Access Compliance Report

Public Rights-of-Way

Main Street: KEMPTON_DR Cross Street: SILVER_FOX_RD Location: SE

ADA ID: RPRK211208124957 Ramp Type: Type 1 - Perpendicular Diagonal Initial Pass/Fail: Fail Overall Compliance: No Severity Score: 2

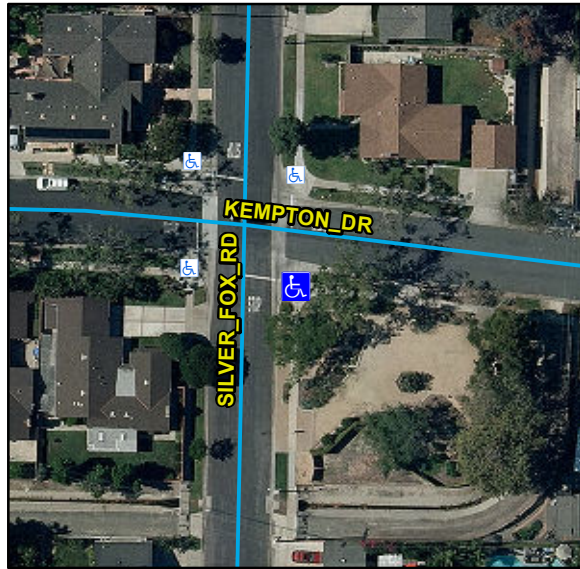
Compliance	Description	Data	Compliance	Description	Data
N/A	Ramp Length (in)	97	N/A	Flare Type LT	
Yes	Ramp Width (in)	48			N/A
Yes	Ramp Run Slope (%)	6	N/A	Flare Slope LT (%)	N/A
No	Ramp Cross Slope (%)	2.5	N/A	Flare Traversable LT	N/A
N/A	Landing Present	N/A	N/A	Flare Type RT	
N/A	Landing Length (in)	N/A			N/A
N/A	Landing Width (in)	N/A	N/A	Flare Slope RT (%)	N/A
N/A	Landing Run Slope (%)	N/A	N/A	Flare Traversable RT	N/A
N/A	Landing Cross Slope (%)	N/A	N/A	DWS Provided	N/A
N/A	Landing Movement Obstructed?	N/A	N/A	DWS Contrast	N/A
	Landing Movement Type	N/A	N/A	DWS Length (in)	N/A
N/A	Landing Shared	N/A	N/A	DWS Full Width	N/A
N/A	Clear Space	Yes	N/A	DWS Offset Left (in)	N/A
N/A	Clear Space To Crosswalk (in)	N/A	N/A	DWS Offset Right (in)	N/A
N/A	Marked Crosswalk 1	No	N/A	Marked Crosswalk 2	No
	Crossing 1 Direction	N		Crossing 2 Direction	W
	Marked Crosswalk 1 Width (in)	N/A		Marked Crosswalk 2 Width (in)	N/A

N/A	Ramp Inside Crosswalk 1	N/A	Yes	Ramp Inside Crosswalk 2	N/A
	Crossing 1 Slope (%)	5.9		Crossing 2 Slope (%)	4.7
	Crossing 1 Cross Slope (%)	1.2		Crossing 2 Cross Slope (%)	2.1
N/A	Gutter Ponding	N/A	N/A	Curb Slope	0.2
Yes	Gutter Lip Height (in)	0		Road Run Slope (%)	1.4
N/A	Gutter Run Slope (%)	N/A		Road Cross Slope (%)	0
N/A	Gutter Cross Slope (%)	N/A			
Yes	Overall Surface Condition: Acceptable		No	Perp Joint Present	No
	Cross Gutter Present?	Yes		Spandrel Present?	Yes
	Replace Cross Gutter?	No		Replace Spandrel?	No

Remove & Replace Curb Ramp With Two New Directional Ramps or Equivalent.
